## 18C Operator Interface Equipment Characterization

The information in this appendix of the reference ABWR DCD, including all subsections and figures, is incorporated by reference with the following departures and a supplement.

STD DEP T1 3.4-1 (Figure 18C-8)

Figure 18C-8 Overall Configuration of Operator Interface System

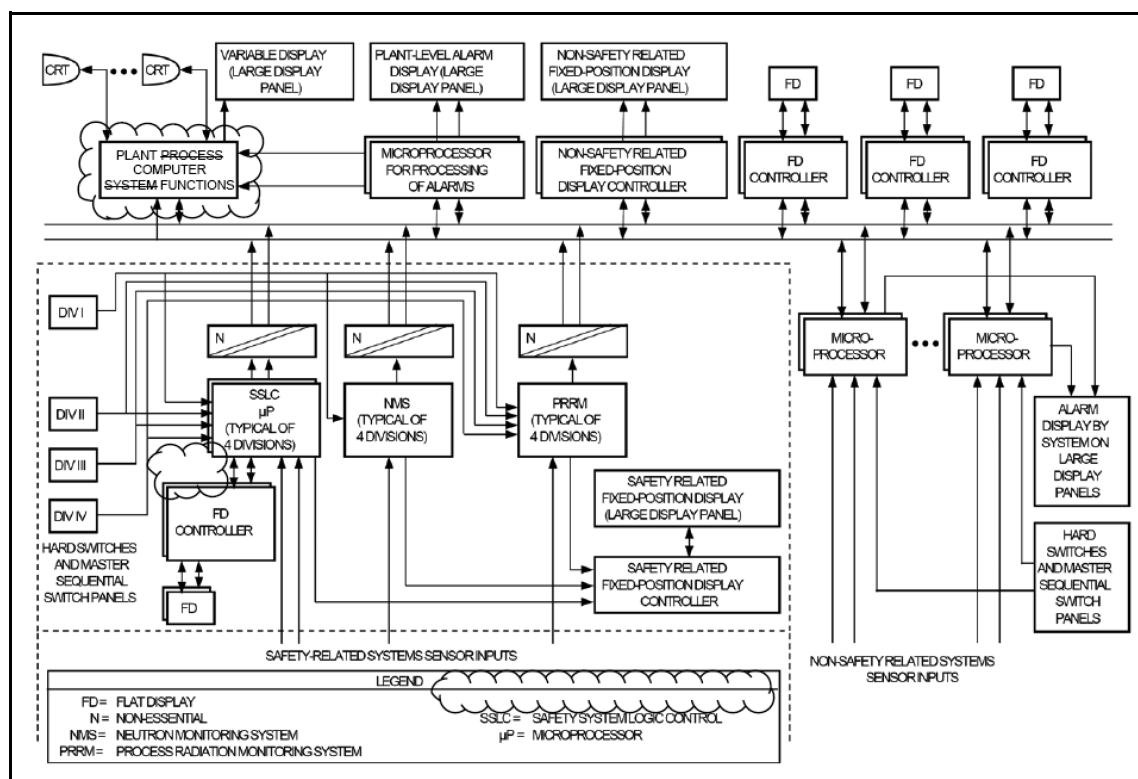
STD DEP T1 3.4-1

*A characterization of the plant instrumentation and control systems architecture which supports the control room operator interface is illustrated in Figure 18C-8. As shown in Figure 18C-8, display and control capability for both safety-related and non-safety-related systems are driven by microprocessors which are independent of the redundant plant process computer functions. This assures the ability to safely shut down the plant in the unlikely event of computer failure. In the case of the safety-related systems, the microprocessors are divisionally dedicated and are each electrically isolated from the rest of the system.*

The instrumentation and control systems architecture is not identical to the conceptual design described in Appendix 18C. The changes in the next paragraph reflect the architecture and configuration.

~~The plant wide, fiber optic Essential Multiplexing System (EMUX) provides the communications network for the system. This multiplexing system is actually a series of data acquisition and control networks, separate networks being provided for safety related and non safety related plant systems.~~ The data communication function includes both safety-related and non-safety-related communication performed by separate networks as described in Section 7.9S.
